**ENCLOSURE: REPORT FROM WSP**

Regarding: Barry Building (11973 San Vicente Boulevard, Los Angeles, CA 90049)  
Opponent Expert's Report review

Per your request, we have reviewed Observation Letter by Alpha Structural Inc, dated November 15.2025, regarding the Barry Building located at 11973 San Vicente Boulevard, Los Angeles, CA 90049. (Reference Exhibit A)

**Figure 3.1:** Existing Shear Wall Locations

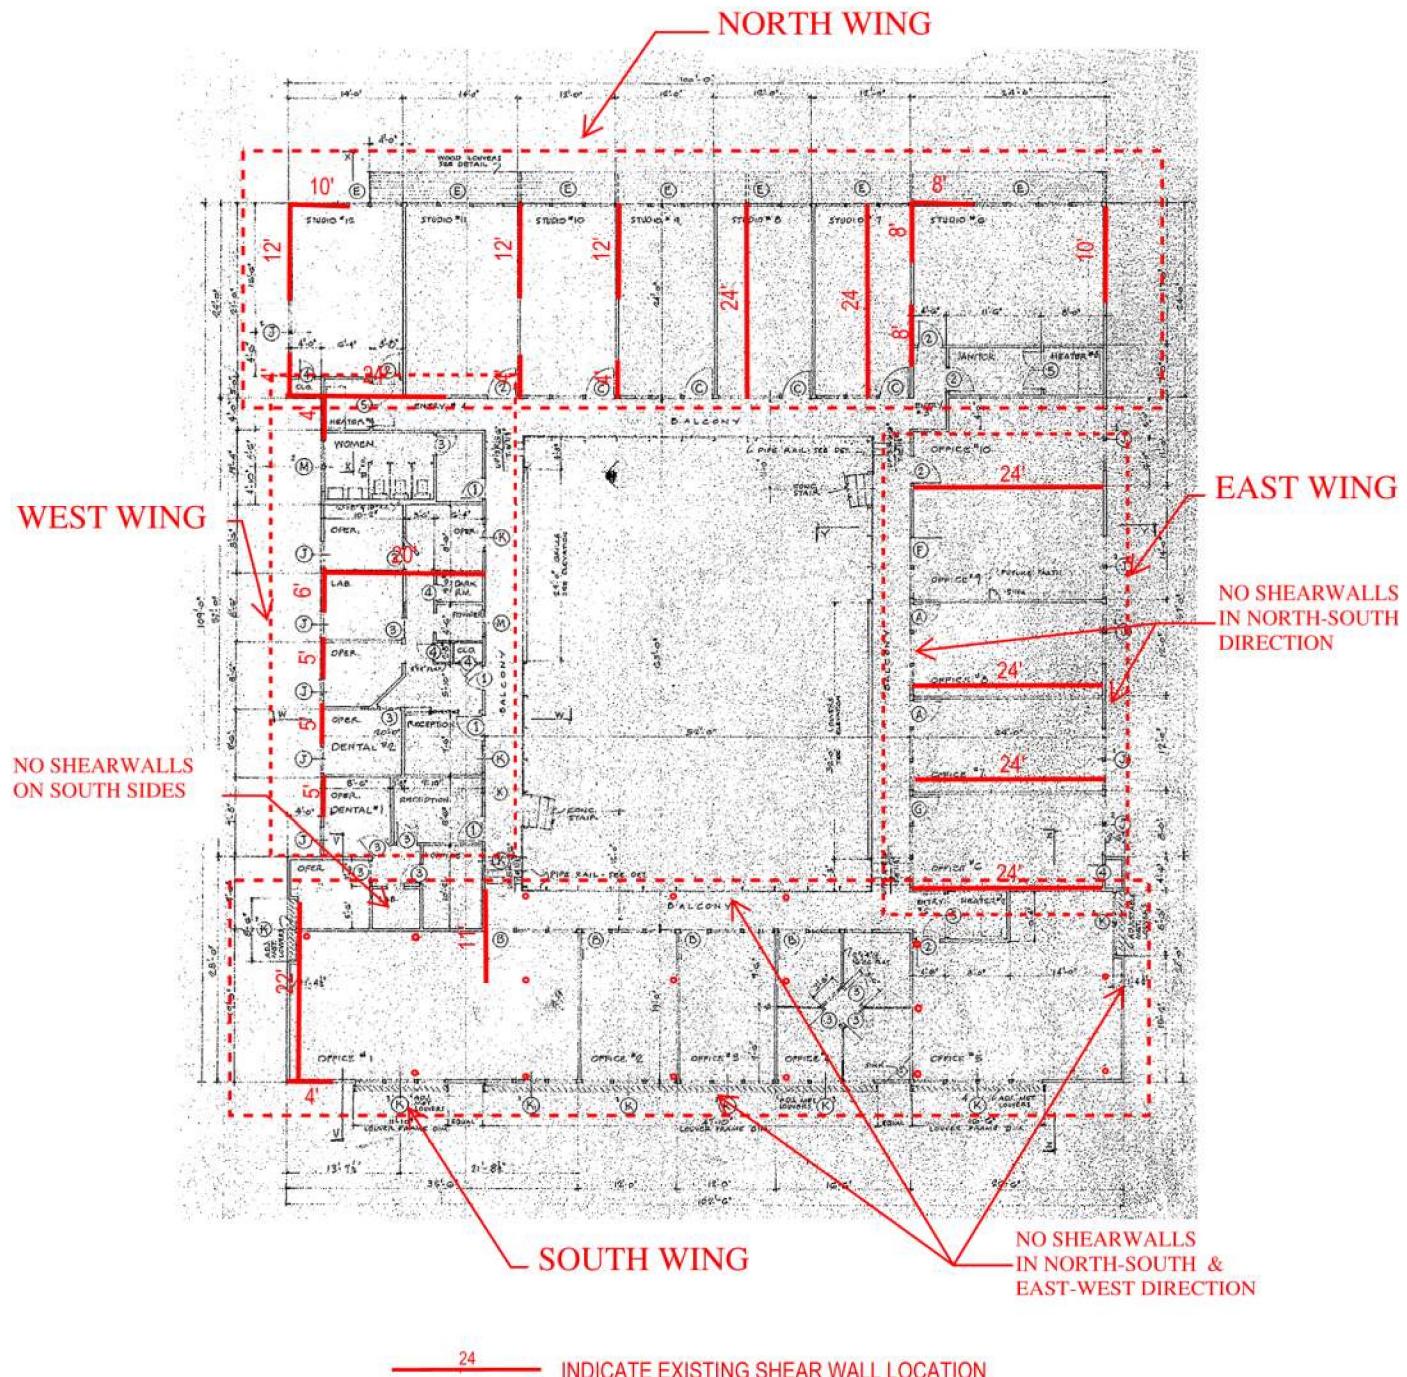
In the north-south direction, roughly 120 feet of existing walls are located, such that they act as lateral resisting elements. In the east-west direction, roughly 42 feet of existing walls are located, such that they act as lateral resisting elements. The DCR for the walls in the north-south direction is 230% overstressed. The DCR for the walls in the east-west direction is 650% overstressed.

In the north-south direction, there is no existing wall located as a lateral resisting element. The exterior wall along grid H and the interior courtyard wall along grid G do not contain structural elements that can be identified as a lateral resisting element. In the east-west direction, roughly 90 feet of existing walls are located as lateral resisting element. The DCR for walls in the north-south direction cannot be determined since no lateral resisting element can be identified. Significant lateral displacement may be expected in the north-south direction of the east wing during a seismic event. The DCR for walls in the east-west direction is 190% overstressed.

In the north-south direction, roughly 50 feet of existing walls are located, such that they act as a lateral resisting element. In the east-west direction, roughly 40 feet of existing walls are located, such that they act as a lateral resisting element. There is no wall located at the south end of the wing. Significant lateral displacement may be expected in the east-west direction during a seismic event. The DCR for the walls in the north-south direction is 360% overstressed. The DCR for the walls in the east-west direction is 400% overstressed.

**Figure 7.1:** Conceptual Shear Wall and Steel Moment Frame Locations

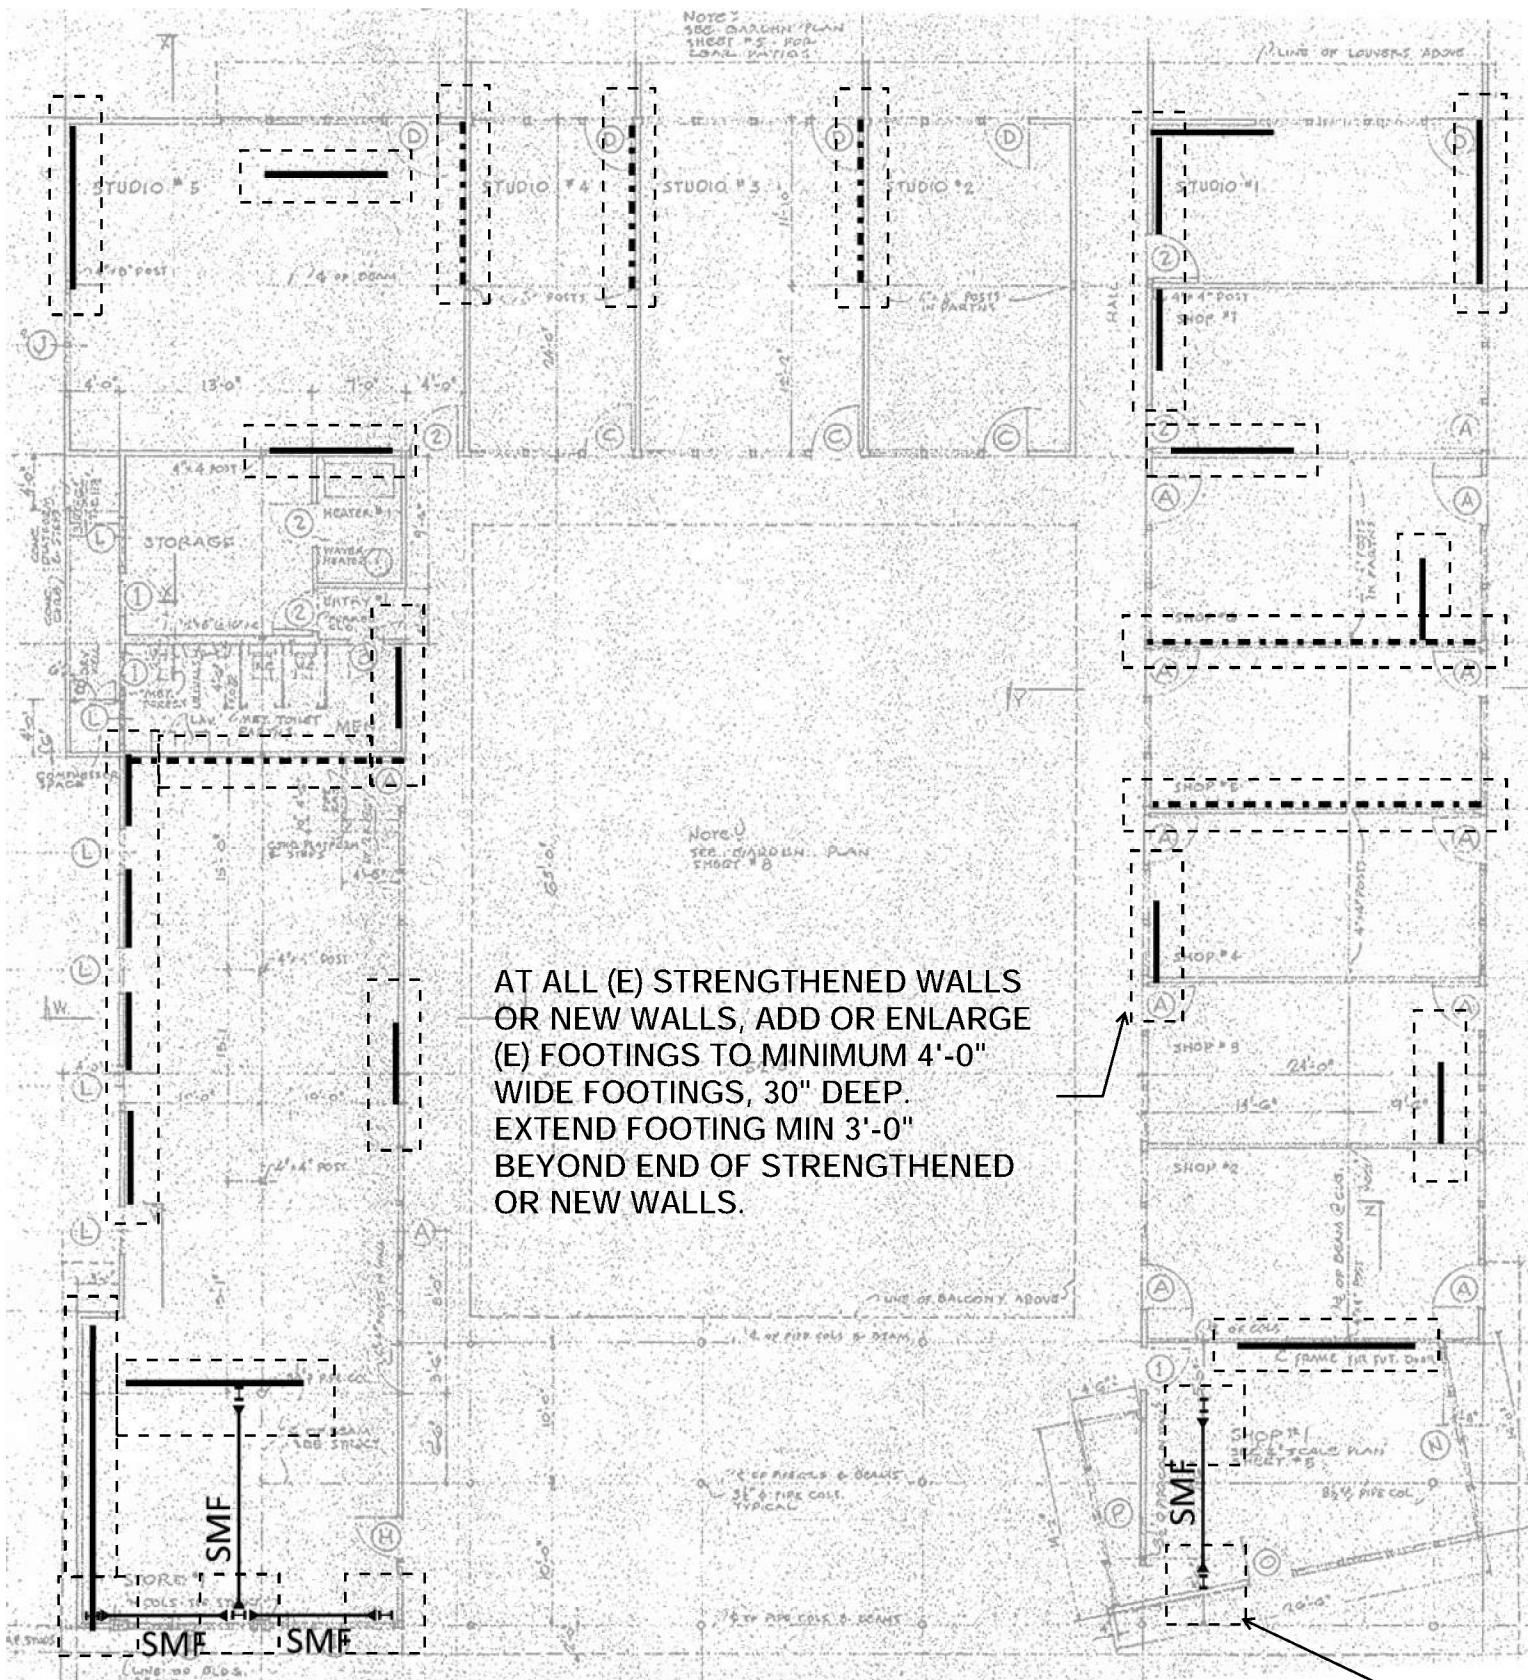
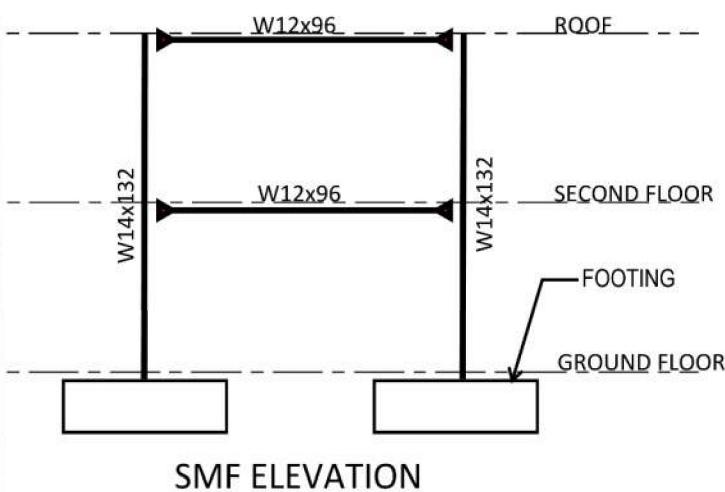
To conform to the seismic force resisting requirements for a new structure, we propose a seismic retrofit scheme that includes strengthening the existing walls, adding new 2-story shear walls, and new steel moment frames. (See Figure 7.1 for conceptual shear wall and steel moment frame locations)

- 10'-0" LONG WOOD SHEAR WALL w/1/2" PLYWOOD & 10d@3":12, ADD (2) SIMPSON HD14 AND 4x8 POST EA END.

----- STRENGTHEN (E) WOOD SHEAR  
WALL w/1/2" PLYWOOD &  
10d@3":12, ADD (2) SIMPSON  
HD14 AND 4x8 POST EA END.

TYPICAL AT ALL FLOOR AND ROOF:  
ADD 3/4" FLOOR AND ROOF PLYWOOD  
OVER (E) SHEATHING AND NAIL  
w/10d@4:12.

— NEW FOOTINGS 6'-0" x 6'-0" x  
— 30" DEEP FOOTINGS UNDER  
ALL SMF COLUMNS, U.N.O.
